10/591,912

Jacques-Yves Bourgon

Office Action Summary	Application No. 10/591,912	Applicant(s) BOURGON ET AL.	
	Examiner STEPHANIE JENNINGS	Art Unit 4135

DETAILED ACTION

FIG - 4

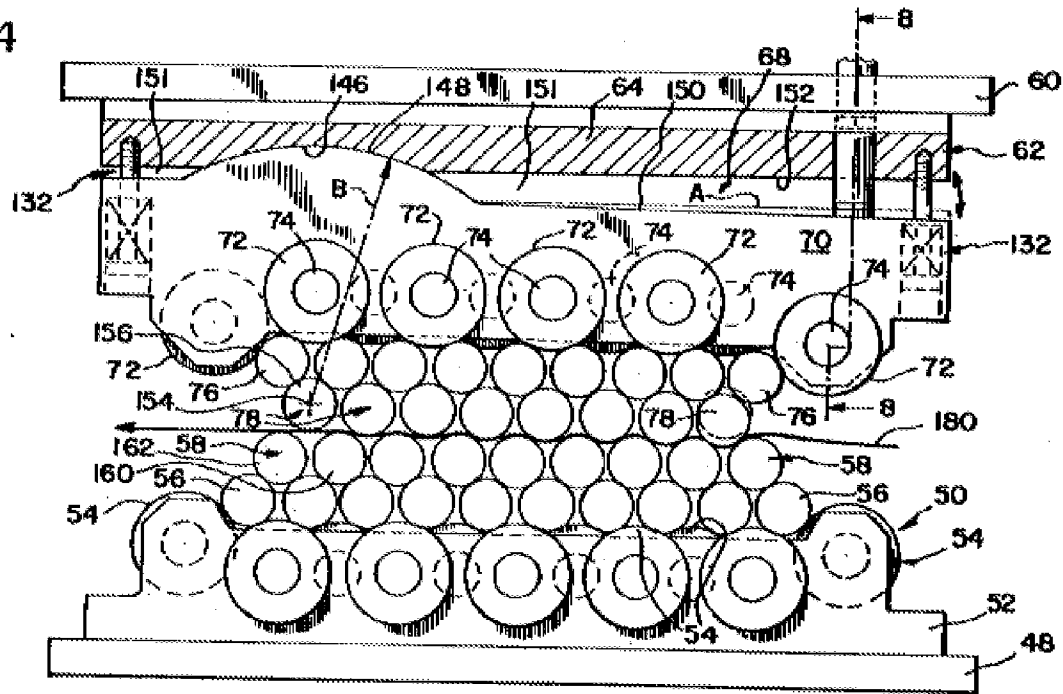
Limitations from claim 1, tensionless leveller (figure 4) intended for levelling a metal strip (180), having an entry and an exit, comprising $n+1$ motorized rolls (54, 56, 58, 72, 76, 78), of the type comprising two superposed cassettes (48, 60) each supporting at least $n/2$ rolls (54, 56, 58, 72, 76, 78) of constant radius R , offset with respect to one another and placed alternately above and below the path of the strip (180), the axis of each of the rolls (54, 56, 58, 72, 76, 78) of one cassette (48, 60) being separated from the axis of the immediately successive roll (54, 56, 58, 72, 76, 78) of the other cassette by a centre-to-centre spacing E_k , in which:

Bradlee discloses the claimed invention except for the center-to-center spacing ratios. It would have been obvious to one having ordinary skill in the art at the time the invention was made to design the apparatuses with precise center-to-center spacing ratios, since it has been held that where the general conditions of a claim are disclosed in the prior art, discovering the optimum or workable ranges involves only routine skill in the art. *In re Aller*, 105 USPQ 233.

Limitations from claim 2, leveller (figure 4) according to claim 1, in which $n \geq 8$ (column 3, lines 5-64).

Bradlee discloses the claimed invention except for explicit enumeration of the rolls. It would have been obvious to one having ordinary skill in the art at the time the invention was made to add additional rolls to the invention, since it has been held that mere duplication of essential working parts of a device involve only routine skill in the art. Additional rolls to the leveller would result in a smoother, more defect-free product. *In re Regis Paper Co. v. Bemis Co.*, 193 USPQ 8.

Limitations from claim 3, leveller (figure 4) according to either of claims 1 and 2, in which, when the thickness of the strip (180) to be levelled is between 0.5 and 3 mm, $14 \leq n \leq 22$ (column 3, lines 5-64).

Bradlee discloses the claimed invention except for the optimal range of metal strip thickness. It would have been obvious to one having ordinary skill in the art at the time the invention was made to design the invention for a specific metal strip thickness, since it has been held that where the general conditions of a claim are disclosed in the prior art, discovering the optimum or workable ranges involves only routine skill in the art. *In re Aller*, 105 USPQ 233.
